**Subject: 80 Lake Street  
Response to Comment Letter**

On behalf of Jim Wu, Terradyn Consultants, LLC is pleased to submit responses to staff comments on the Site Plan application for the 80 Lake Street project. The information enclosed was prepared in response to the staff review comments provided on April 12, 2024.

### **Comments from Katherine Cook, Planning Coordinator, Dated April 12, 2024:**

PROJECT: LAKE STREET SCHOOL APARTMENTS  
 80 LAKE STREET, AUBURN, MAINE  
 SHEET TITLE: FIRE TRUCK TURNING PLAN  
 CLIENT: JIM WU  
 279 CENTER STREET  
 AUBURN, MAINE 04210  
 DATE: 4/3/2024  
 SCALE: 1"=20'  
 JOB NO: 23-75  
 SHEET: C-2.0

**Playground Boss - PGB-34524**

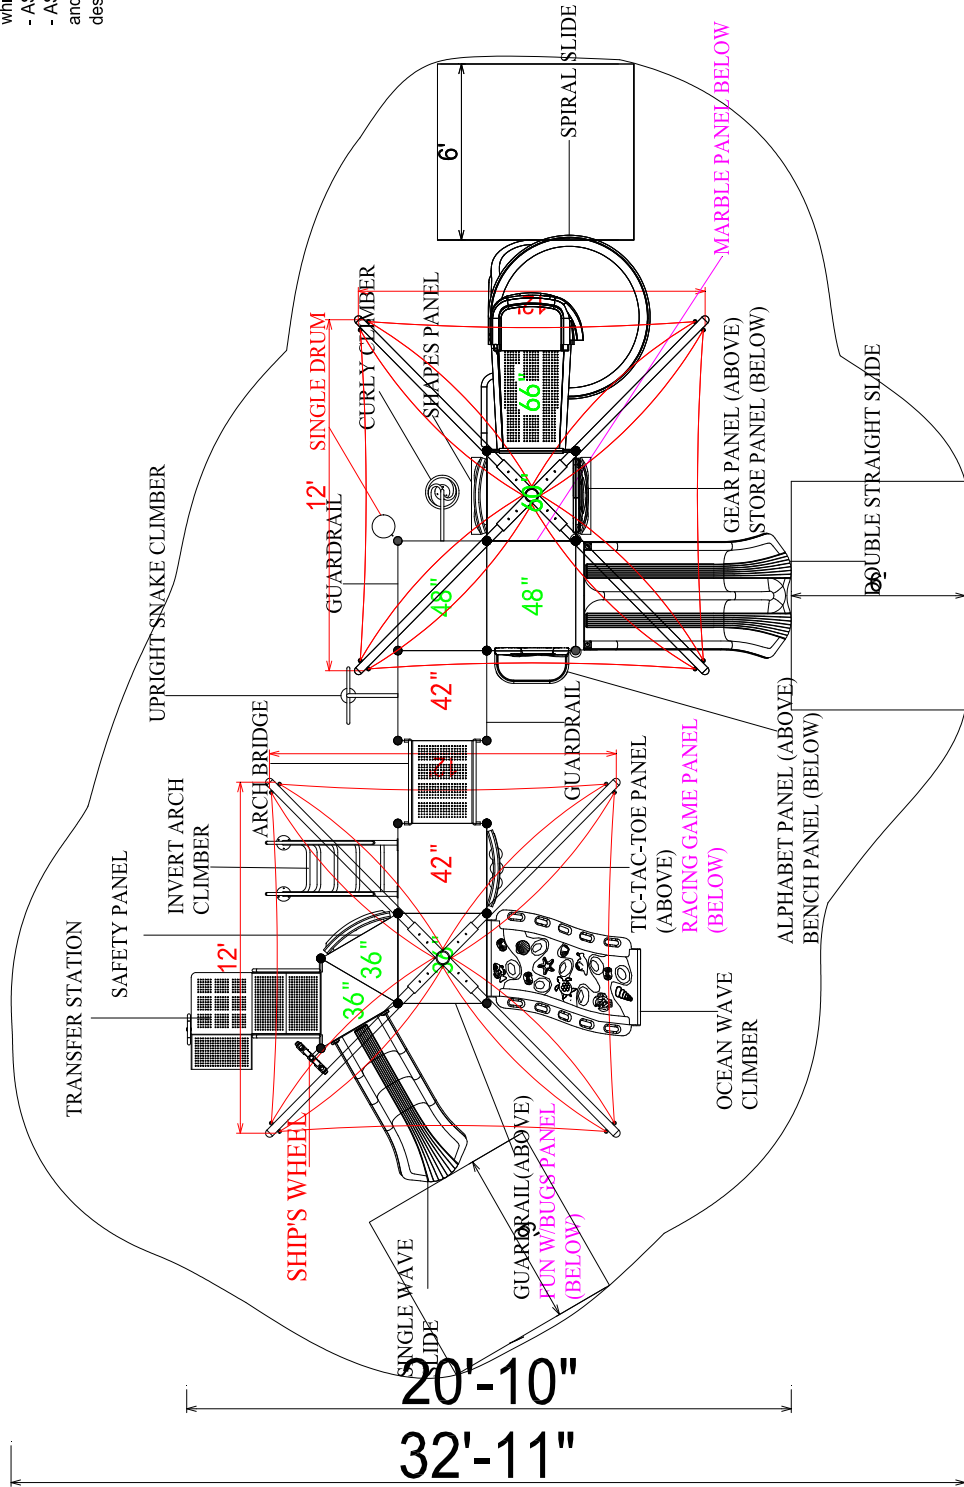
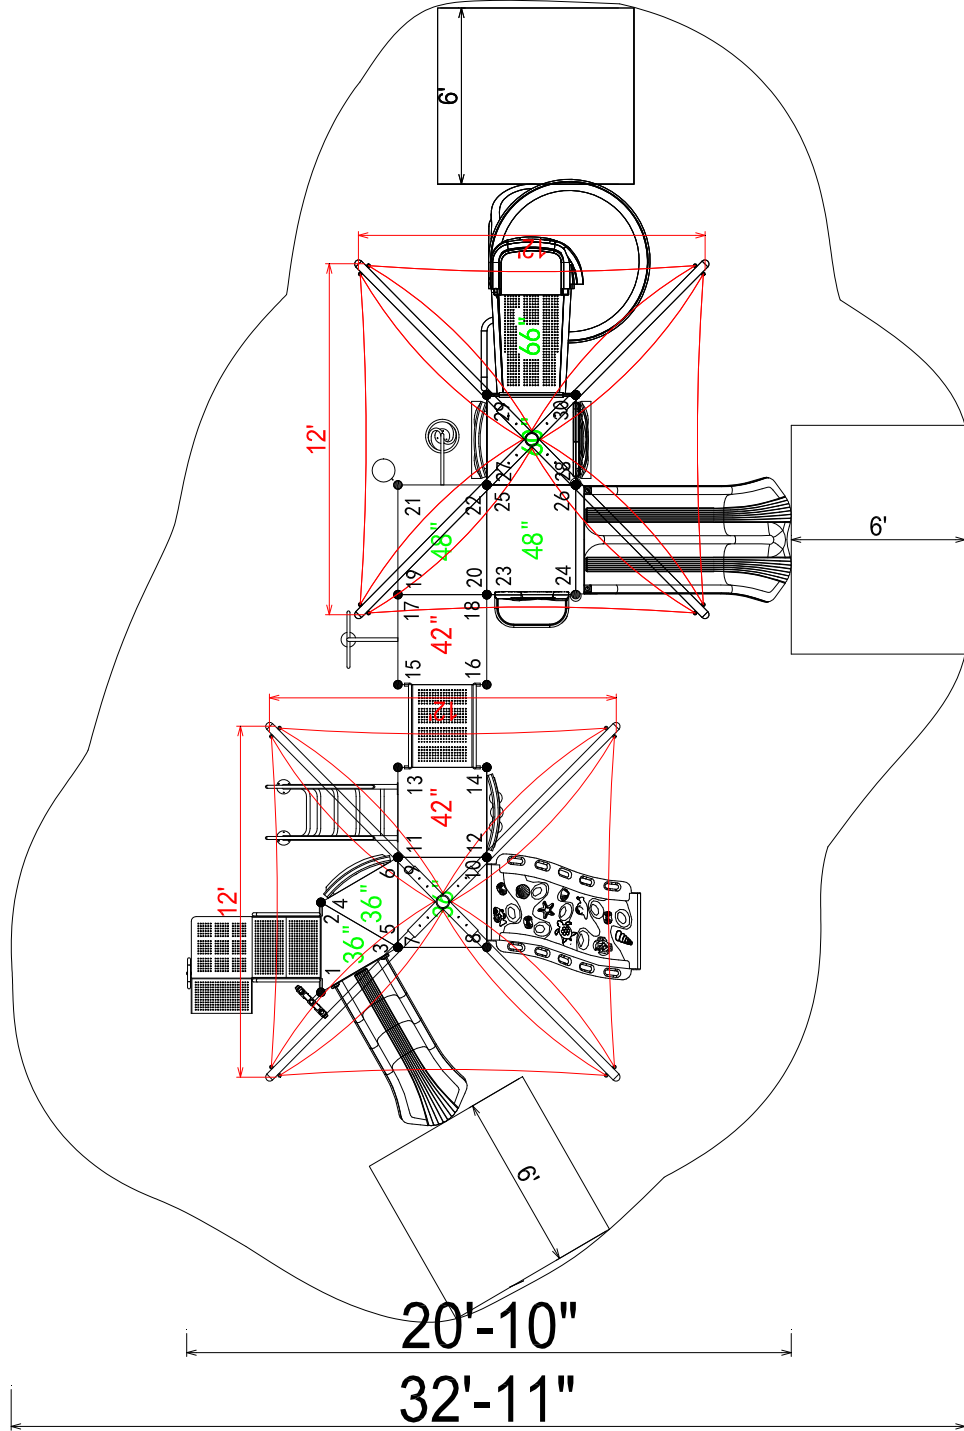
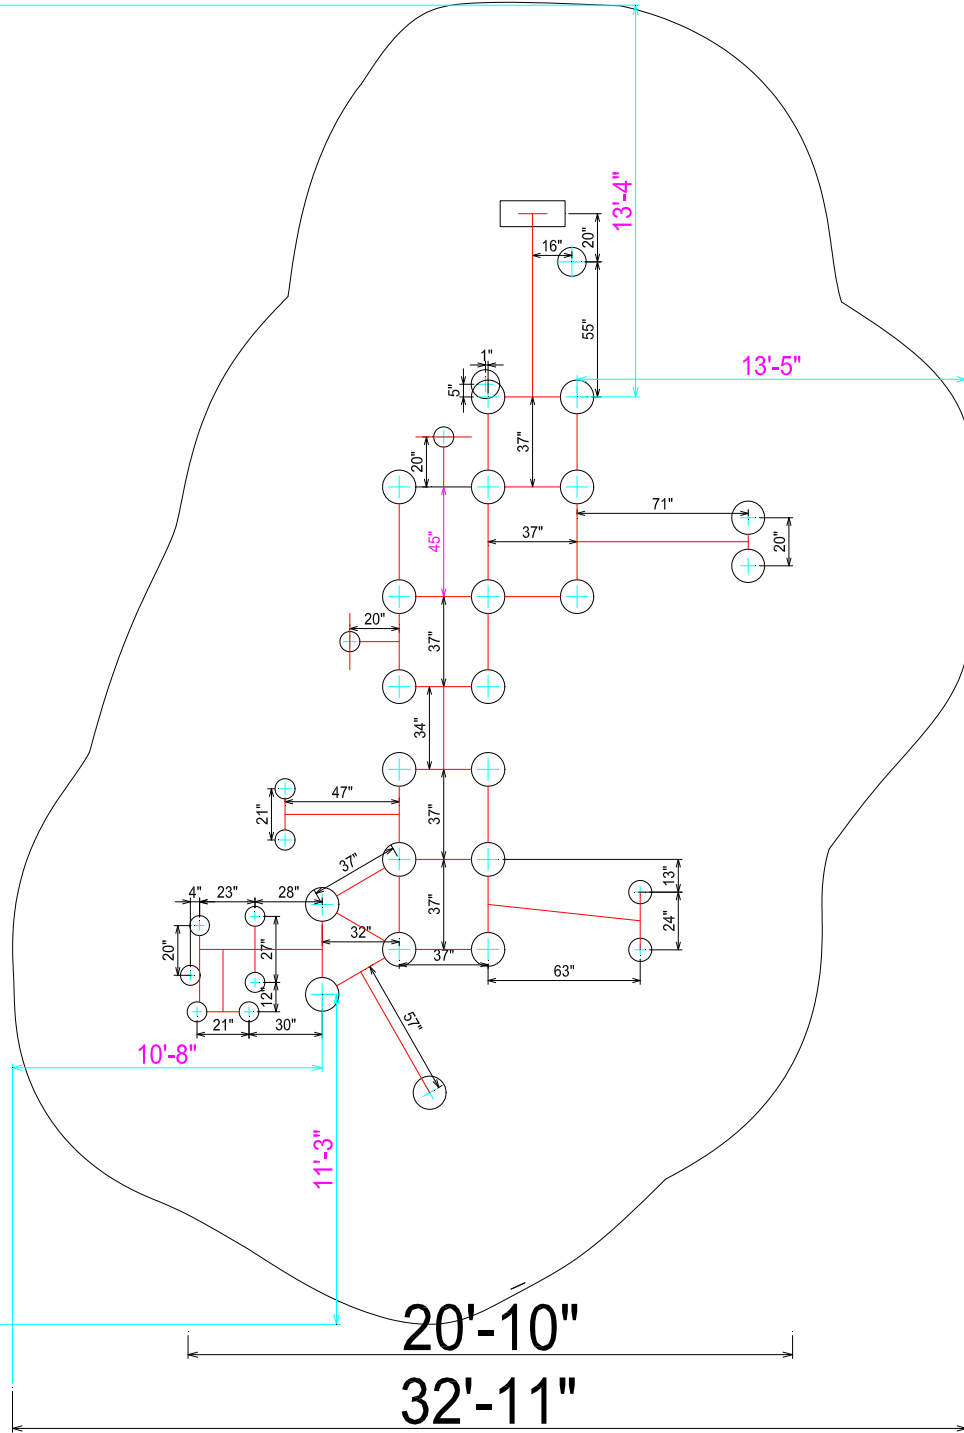
2. *Are you still planning on including the playground as part of the project? You will need to submit information on the playground equipment as part of the permit application.*

**Comment Response:** The applicant still intends to install a playground as part of the proposed project; additional information regarding the playground is attached to this letter.

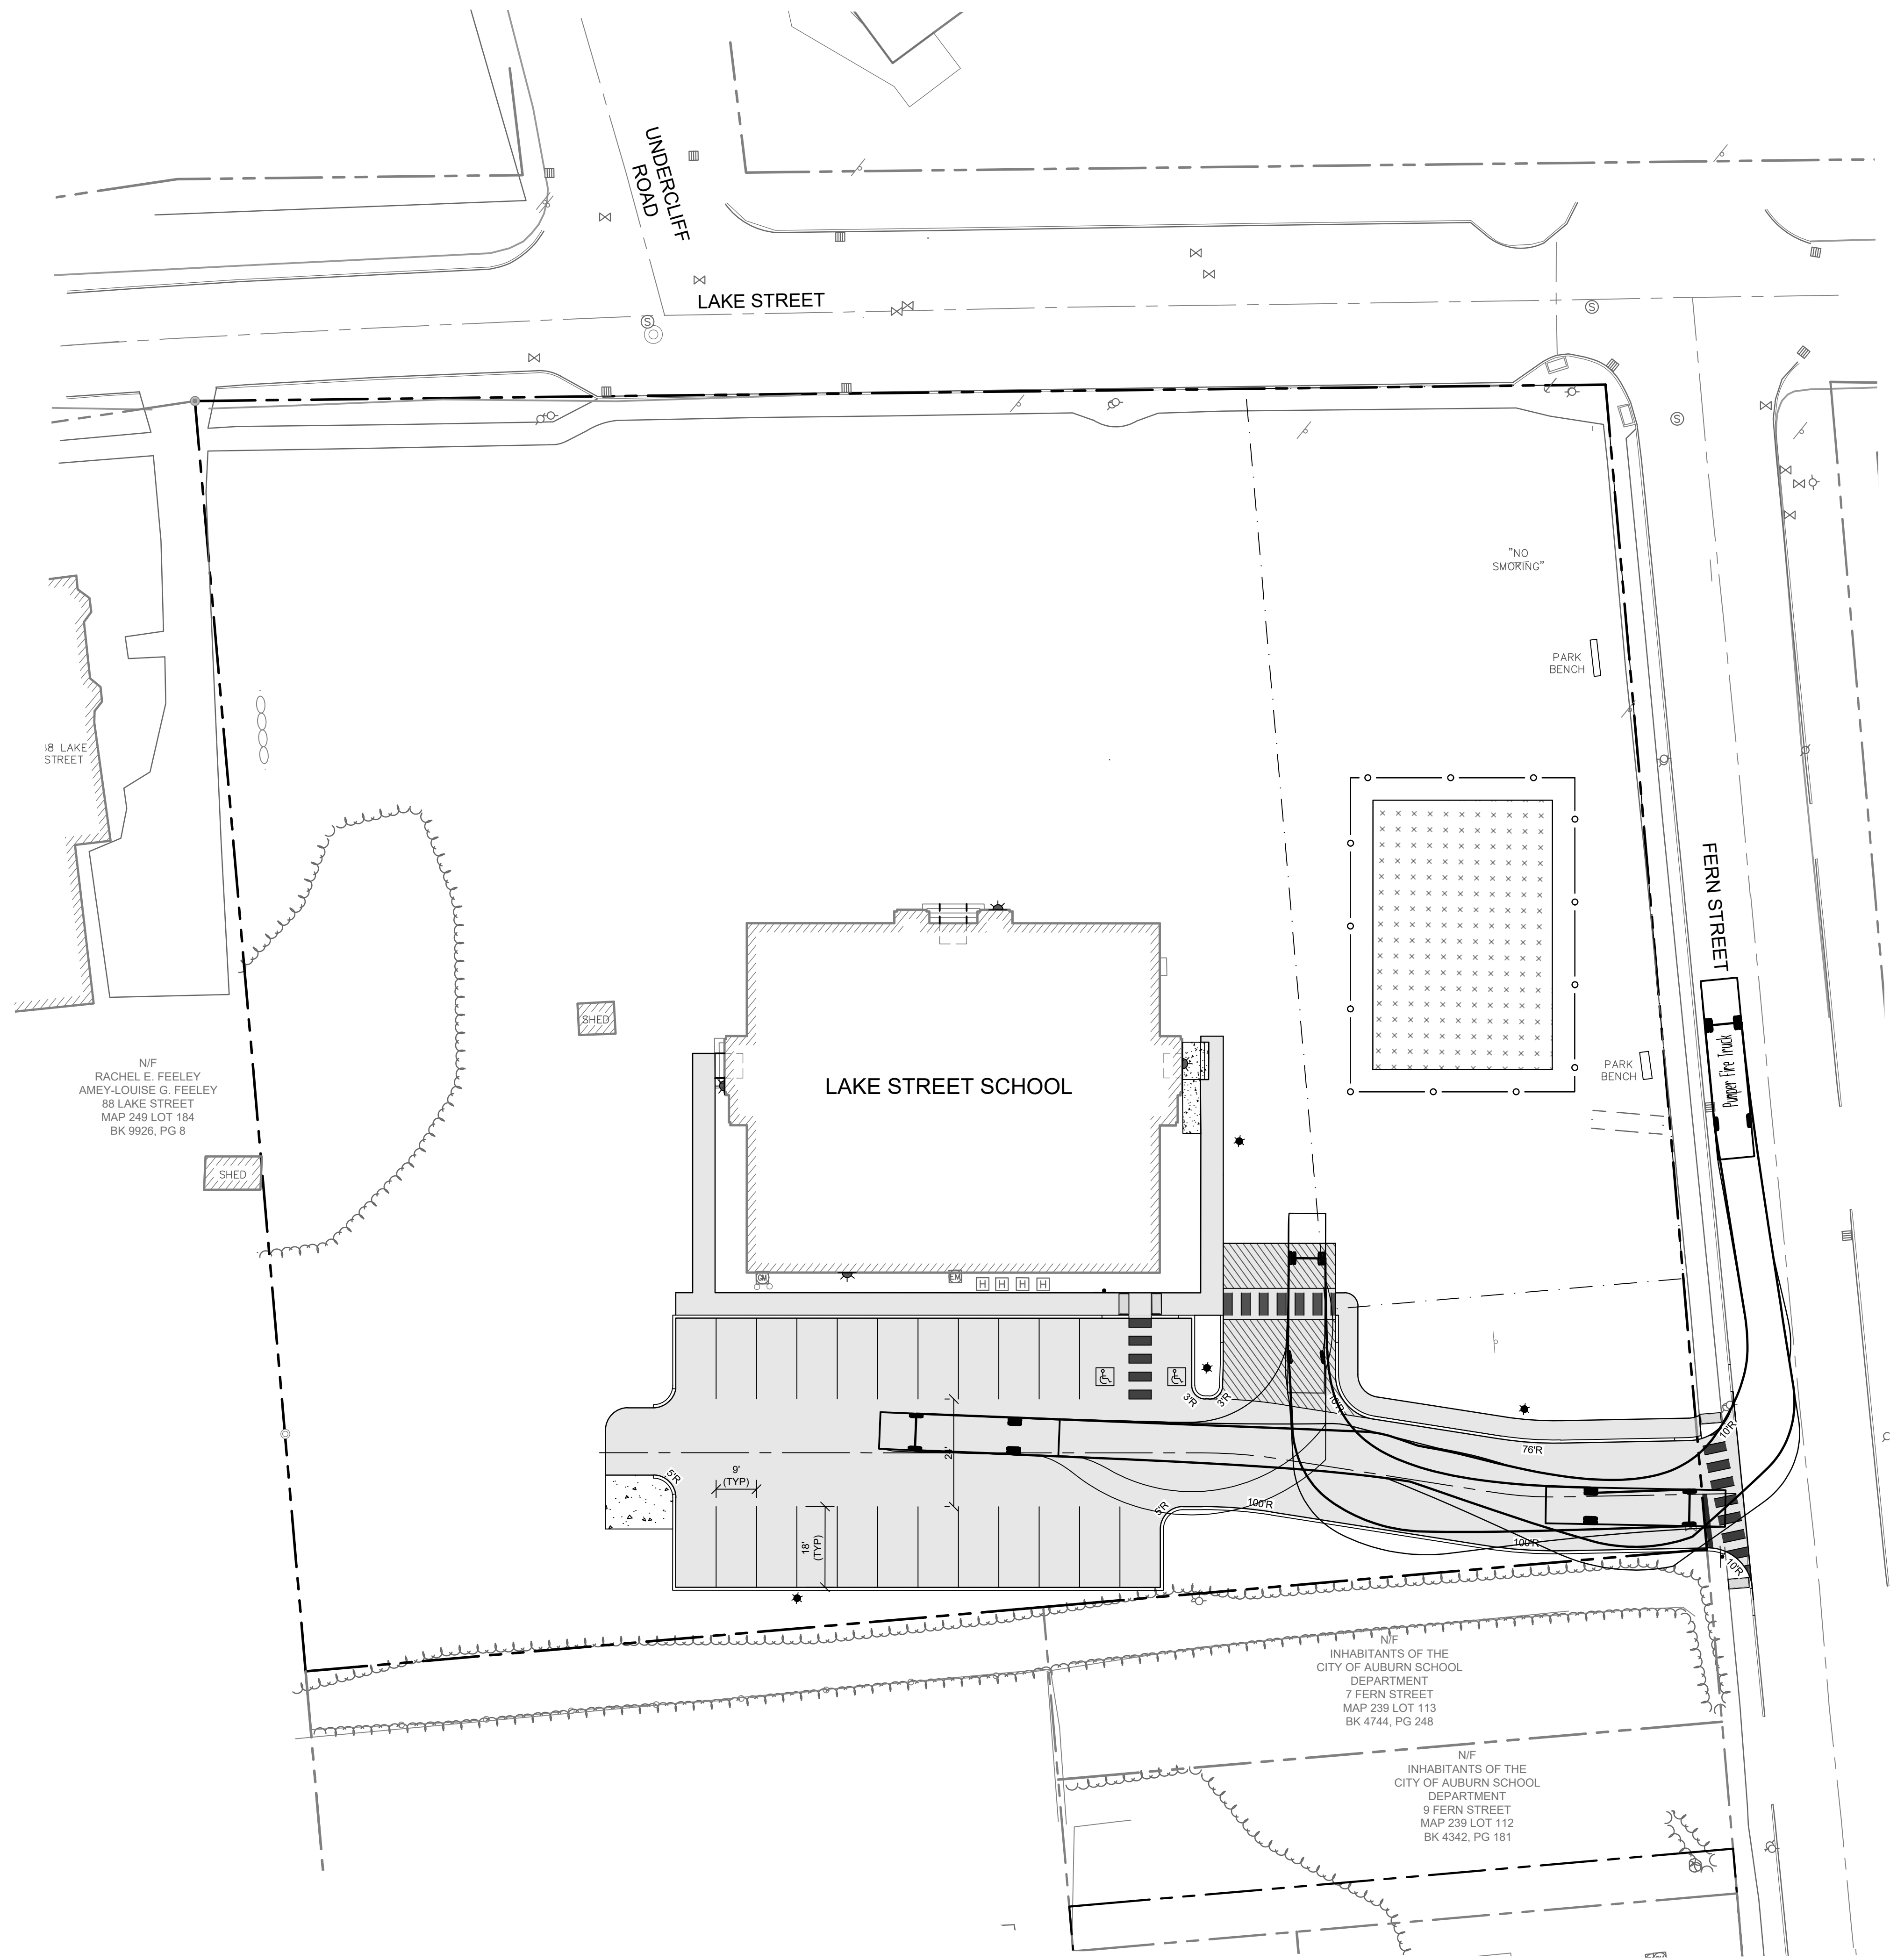
4. *We will need to see the turning radius movement for the fire apparatus. It is not clear that service vehicles will be able to make the required turning.*

**Comment Response:** An additional turnaround has been added to the plans, fire truck turning templates are attached to this letter.
